RS-12-021

Clinton Power Station, Unit 1
Facility Operating License No. NPF-62
NRC Docket No. 50-461

Subject: Additional Information Related to License Amendment Request to Modify
Technical Specifications Section 3.8.1, "AC Sources – Operating,"
(TAC NO. ME6876)

ATTACHMENT
Additional Information Related to License Amendment Request to Modify Technical Specifications Section 3.8.1, "AC Sources – Operating"

Figure 1: Voltage Profile for the CPS Division 1 DG from December 2011 Integrated Test

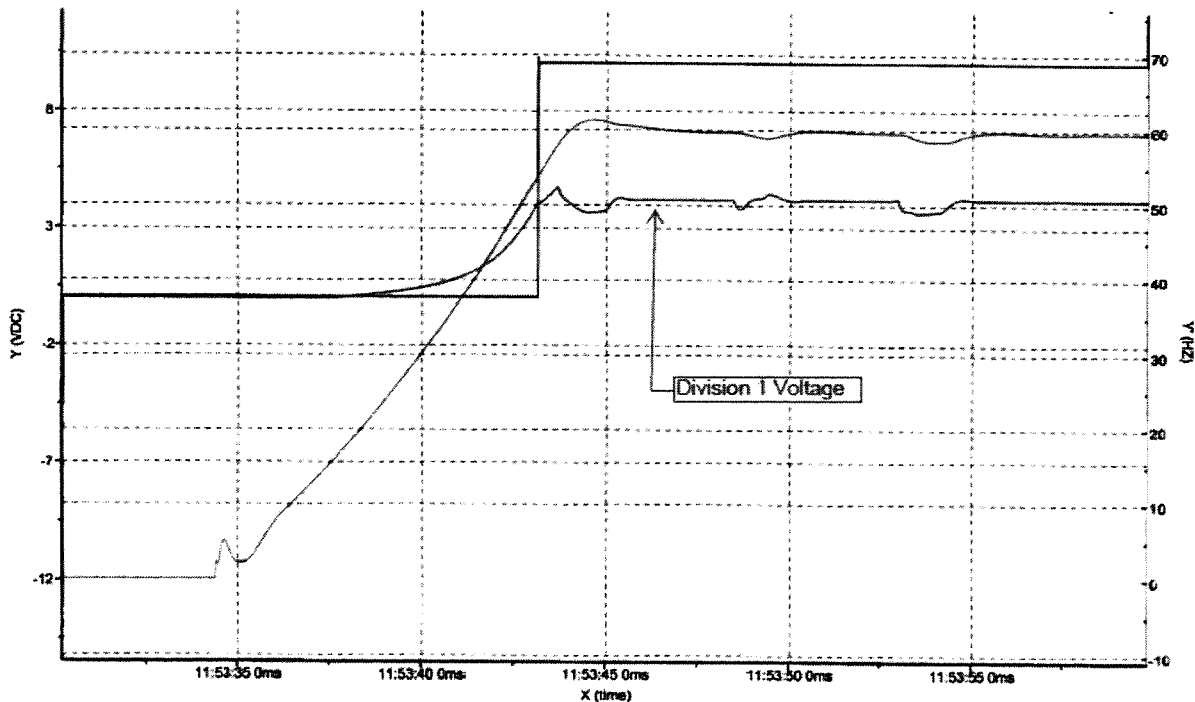
- b. The voltage profiles(s) at 4160 V safety-related buses when powered by EDGs, during the sequencing of large safety-related loads for a loss of coolant accident signal, based on analysis or test.***

The voltage profiles for all three divisions from the integrated tests conducted in December 2011 are shown in Figures 1, 2, and 3 below for the Division 1, 2, and 3 emergency diesel generator (EDG), respectively. These voltage profiles include EDG starting and sequencing of large safety-related loads. As shown on the figures, the Division 1 EDG output voltage stabilized at approximately 4220V, the Division 2 EDG output voltage stabilized at approximately 4230V and the Division 3 EDG output voltage stabilized at approximately 4140V.

In summary and as shown on Figures 1, 2, and 3 from the integrated testing, the voltages for all three EDGs stabilized below 4300V on startup and following sequencing of major safety-related loads. When accounting for instrument uncertainties, Figures 1, 2, and 3 demonstrate that all three EDGs are operated below 4300V during normal operation and during recovery from transient conditions.
